UNITED STATES
NUCLEAR REGULATORY COMMISSION
WASHINGTON, D.C. 20555-0001

SUBJECT: NINE MILE POINT NUCLEAR STATION, UNITS 1 AND 2 - STAFF
ASSESSMENT OF INFORMATION PROVIDED PURSUANT TO TITLE 10 OF
THE *CODE OF FEDERAL REGULATIONS* PART 50, SECTION 50.54(f),
SEISMIC HAZARD REEVALUATIONS FOR RECOMMENDATION 2.1 OF THE
NEAR-TERM TASK FORCE REVIEW OF INSIGHTS FROM THE FUKUSHIMA
DAI-ICHI ACCIDENT (TAC NOS. MF3973 and MF3974)

STAFF ASSESSMENT BY THE OFFICE OF NUCLEAR REACTOR REGULATION
RELATED TO SEISMIC HAZARD AND SCREENING REPORT
NINE MILE POINT NUCLEAR STATION, UNITS 1 AND 2
DOCKET NOS. 50-220 AND 50-410

Figure 3.3-1 Plot of Staff's and Licensee's Base Case Shear-Wave Velocity Profiles for the NMP site

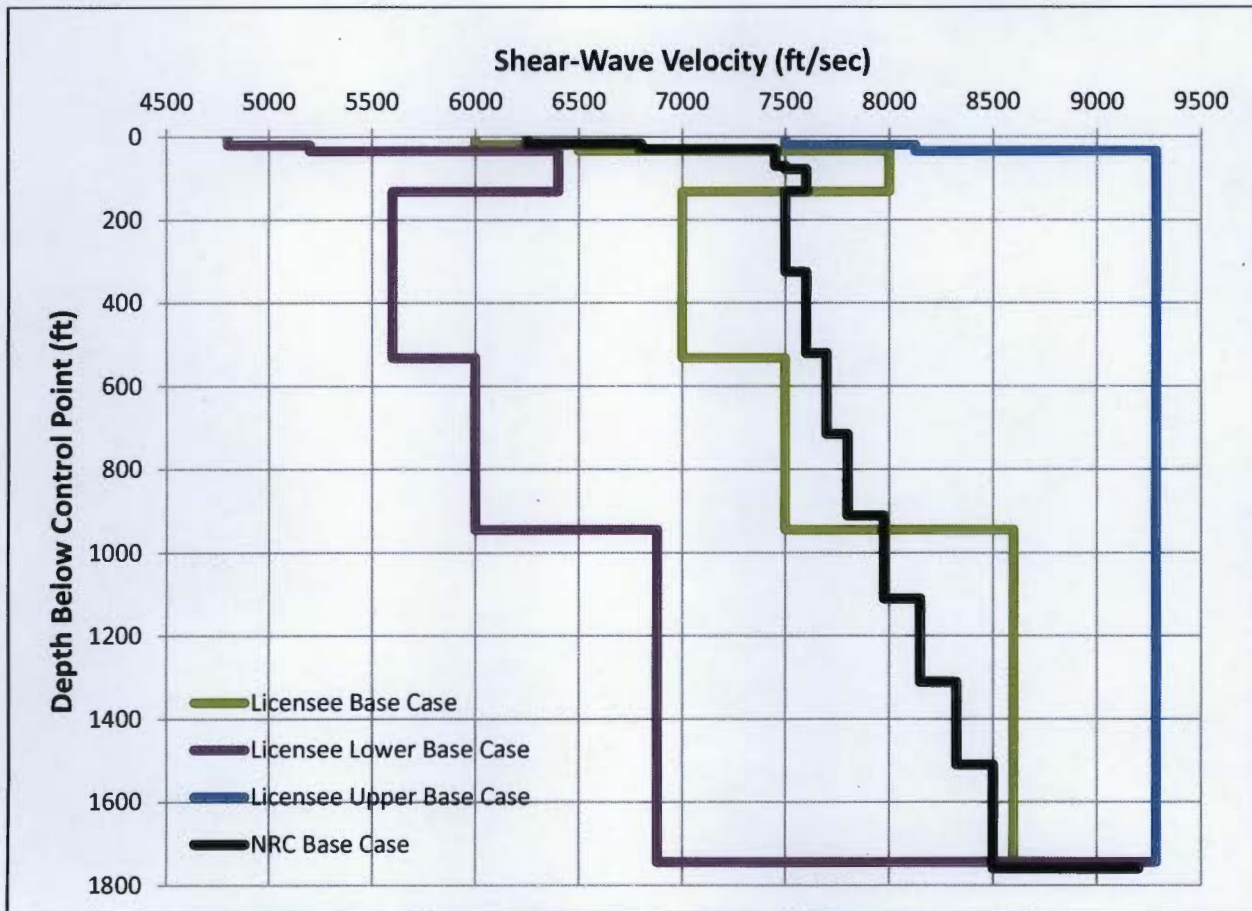
To characterize the subsurface geology, the licensee developed three site base case profiles. The middle, or best estimate, profile was developed using measured shear-wave velocity from nearby cross-hole geophysical investigations. The licensee determined the shear wave velocities for the upper 325 ft [99 m] of rock from measurements near NMP Unit 2, and it determined the velocities for the deeper rock units from measurements at the proposed NMP Unit 3. Upper and lower base case profiles were developed using a natural log standard deviation of 0.18. Figure 3.3-1 of this assessment shows the licensee's three shear-wave velocity base case profiles.

Because the site is well characterized and the velocities reported in the NMP Unit 2 FSAR (Constellation, 2012) and the proposed NMP Unit 3 SAR (UniStar, 2009) are similar, the staff used only a single shear wave velocity profile rather than the three profiles used by the licensee. For the depth interval between the control point and 200 ft [61 m] below the control point, the staff used an average of the measured shear wave velocities at NMP Unit 2 and the proposed NMP Unit 3 for its shear wave velocity profile. For depths between 200 ft [61 m] below the control point and the base of the profile, the staff used the shear wave velocities from the proposed NMP Unit 3. To capture the uncertainty in the depth to base rock, the staff used a value of ± 150 ft [± 46 m], which is considerably less than the ± 524 ft (± 160 m) depth to base rock randomization used by the licensee. Figure 3.3.-1 of this assessment shows the staff's velocity profile compared to the base case profiles developed by the licensee.

Figure 3.3-2 Plot Comparing the Staff's and the License's Median Amplification Functions and Uncertainties for two input loading levels for the NMP site

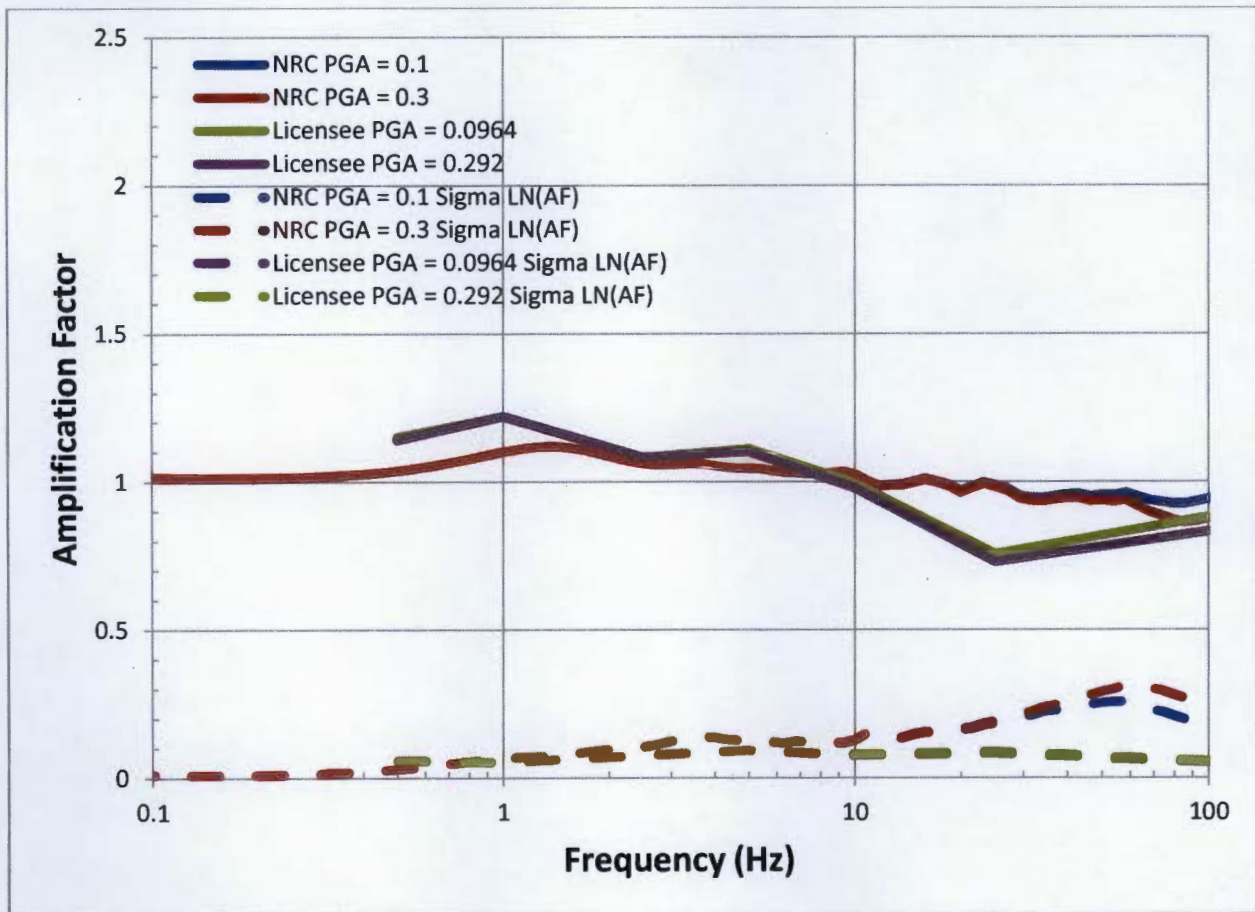
Figure 3.3-2 of this assessment shows a comparison of the staff's and licensee's median site amplification functions and uncertainties (± 1 standard deviation) for two of the eleven input loading levels. Due to the use of very low damping values and modeling of the rock behavior as essentially linear for the range of input loading levels, the staff's confirmatory amplification factors are essentially one for the entire frequency range. Above approximately 10 Hz, amplification functions calculated by the licensee are lower than those developed by the staff due to the greater nonlinearity included in the licensee's analyses.

The staff conducted sensitivity tests to evaluate the licensee's use of (1) multiple base case velocity profiles, (2) higher damping values and the assumption of more nonlinearity over a larger portion of the subsurface profiles, (3) higher kappa values, and (4) a large depth to base rock randomization value. Of these four factors, the higher damping values (3 percent and higher), which the licensee used for the upper 500 ft [152 m] of the rock profile, resulted in the largest difference in the sets of amplification factors developed by the licensee and staff. These differences are shown in Figure 3.3-2 of this assessment for frequencies above 10 Hz.

Figure 3.3-3 Plot Comparing the Staff's and the Licensee's Mean Control Point Hazard Curves at a Variety of Frequencies for the NMP site

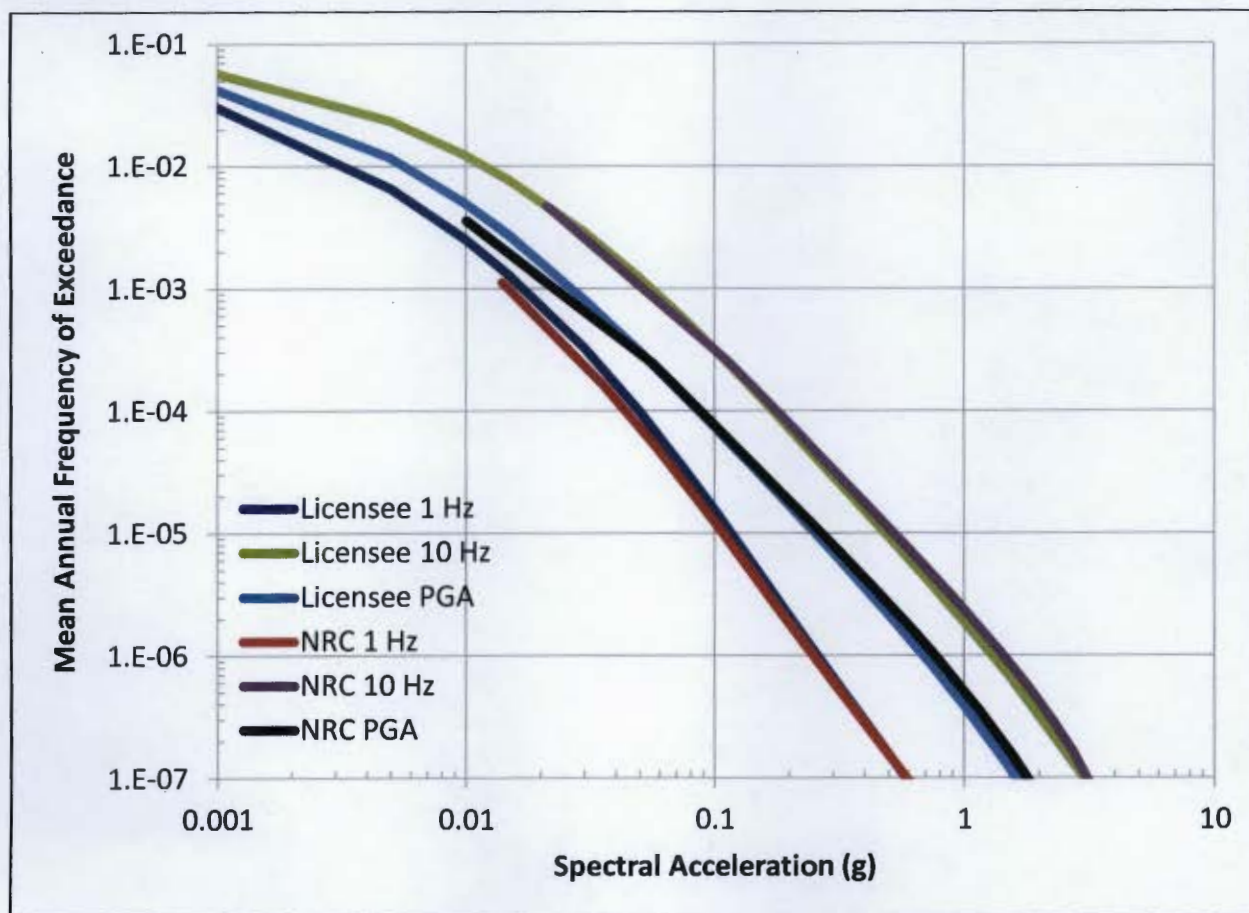
Overall, the licensee's approach to modeling the subsurface rock properties and their uncertainties results in slightly lower site amplification factors relative to the staff's results, particularly at high frequencies. However, as shown in Figure 3.3-3 of this assessment, these differences in the site response analysis do not have a large impact on the control point seismic hazard curves or the resulting GMRS, as discussed below. Appendix B of the SPID provides guidance for performing site response analyses, including capturing the uncertainty for sites with less subsurface data; however, the guidance is neither entirely prescriptive nor comprehensive. As such, various approaches in performing site response analyses, including the modeling of uncertainty, are acceptable for this application.

Figure 3.4-1 Comparison of the Staff's GMRS with Licensee's GMRS and the SSEs for NMP Unit 1 (Red) and NMP Unit 2 (Red dashed).

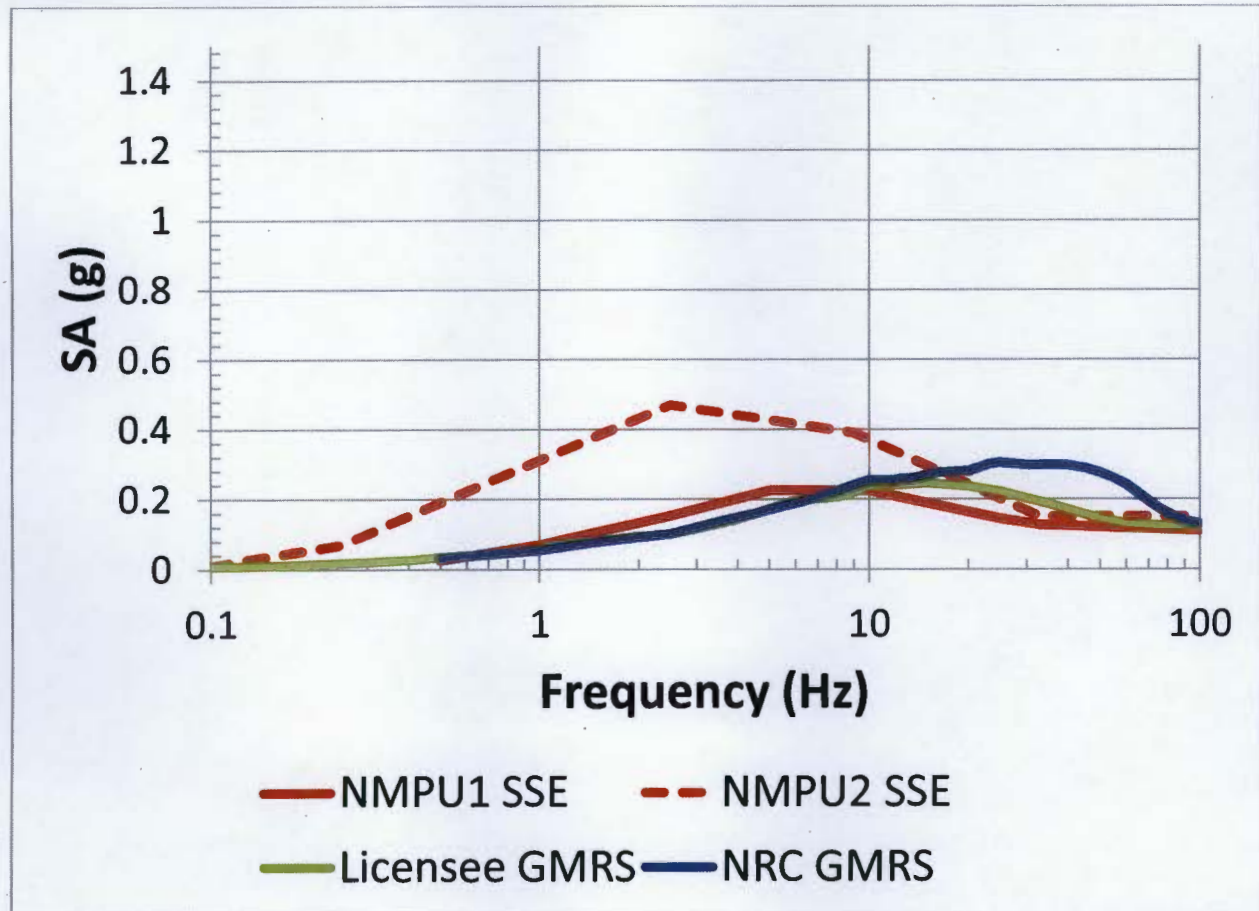
The staff independently calculated the 10^{-4} and 10^{-5} UHRs using the results of its confirmatory PSHA and site response analyses, as described in Sections 3.2 and 3.3 of this staff assessment, respectively. Figure 3.4-1 of the assessment shows a comparison of the GMRS determined by the licensee to that determined by the staff.

As shown in Figure 3.4-1 below, the licensee's GMRS shape is generally similar to that calculated by the staff at frequencies less than 10 Hz. However, NRC staff's confirmatory GMRS is somewhat higher than the licensee's at frequencies above 10 Hz. As described above in Section 3.3, the staff concludes that these minor differences over the higher frequency range are primarily due to the differences in the site response analyses performed by the licensee and staff. The staff concludes that these differences are acceptable for this application because the licensee followed the guidance provided in the SPID with respect to both the PSHA and site response analysis for the NMP site.
